EPA-AA-TEB-511-82-16

**EPA Evaluation of the Freedom Products Hot Tip Device Under
Section 511 of the Motor Vehicle Information and Cost Savings Act**

September 1982

**Test and Evaluation Branch
Emission Control Technology Division
Office of Mobile Sources
U.S. Environmental Protection Agency**

PREFERRED NEEDLE
WITH INSULATED AIR
VAPOR SHIELD TUBE

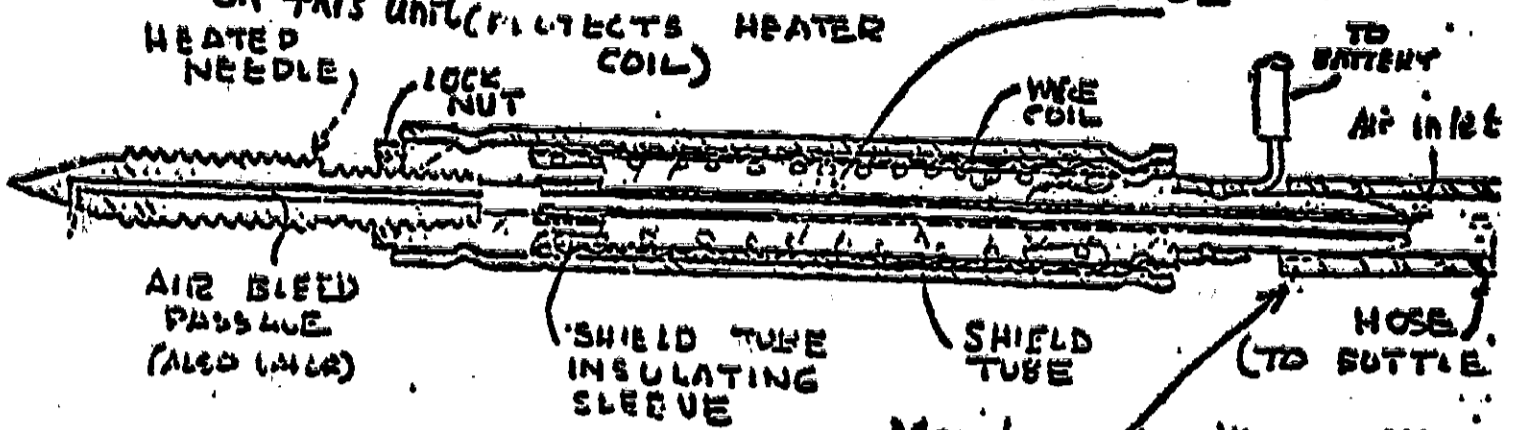
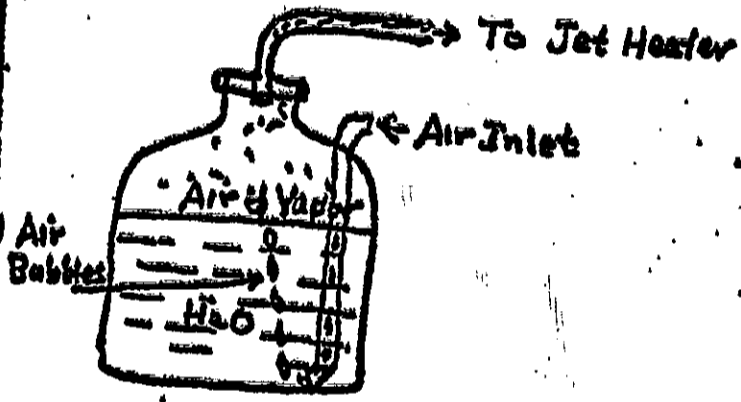
(3) The description of the device provided with the application was superseded by a new description, Attachment E. This patent description adequately described the device being evaluated. The description given of the water vapor air bleed version adequately described the construction of this version but did not adequately indicate how the proper liquid level in the water vapor bottle would be determined. This is critical since the flow of heated air through the idle mixture screw would be strongly influenced by the depth of the air inlet tube (item 76 of figure 1 of the patent application) below the surface of the water.

Future plans are to make tests
with "B" using bottle. I feel it is the best
MODIFIED NEEDLE - WITH CHECK VALVE on
TO PREVENT ESCAPE OF FUMES

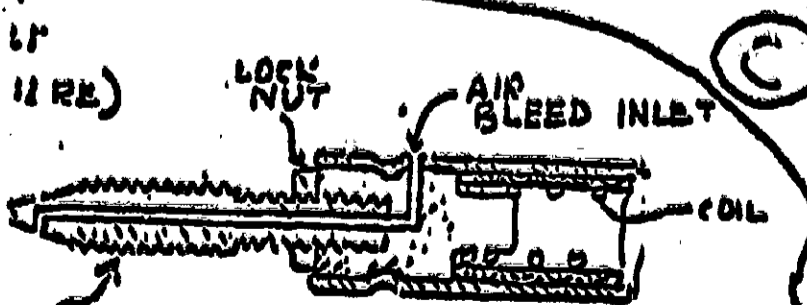
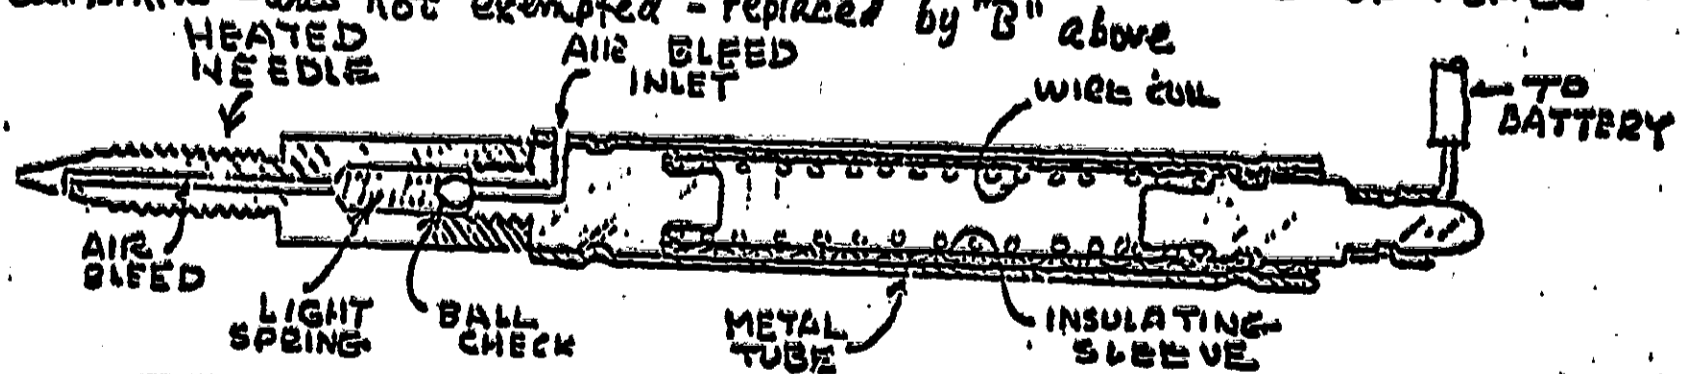
"Modified Needle C with the check valve was submitted to California Air Resources Board. Its purpose was to prevent the bleed back of vapors. The A.R.B. denied us an exemption because it admits particulates from the atmosphere into the engine. It is also more cumbersome to install so we have rejected it." Attachment E.

- d. Modified Needle C with the check valve was submitted to the California Air Resources Board. Its purpose was to prevent the bleed back of vapors. The A.R.B. denied us an exemption because it admits particulates from the atmosphere into the engine. It is also more cumbersome to install so we have rejected it.

This unit designed for
California - was not exempted - replaced by "B" above
